Company	Trenz Electronic GmbH
PCN Number	PCN-20210219
Title	TE0745-02 DDR3 Change and Product Update
Subject	BOM change
Issue Date	2021-03-09

This change affects all Trenz Electronic TE0745 SoMs of revision 02: TE0745-02-*

2.4 #4 Set S/N to not fitted

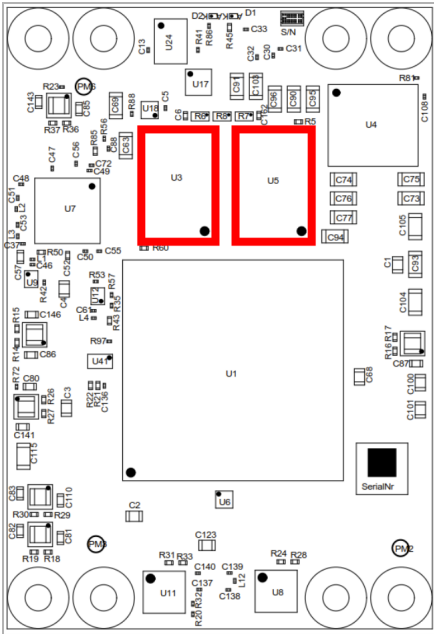
Type: BOM change

Reason: Part is end of life.

Impact: Track it pad no more available. Pin 20 of CPLD was connected via S/N to GND and is now floating. However pin is not used in delivery CPLD Firmware, so no further impact.
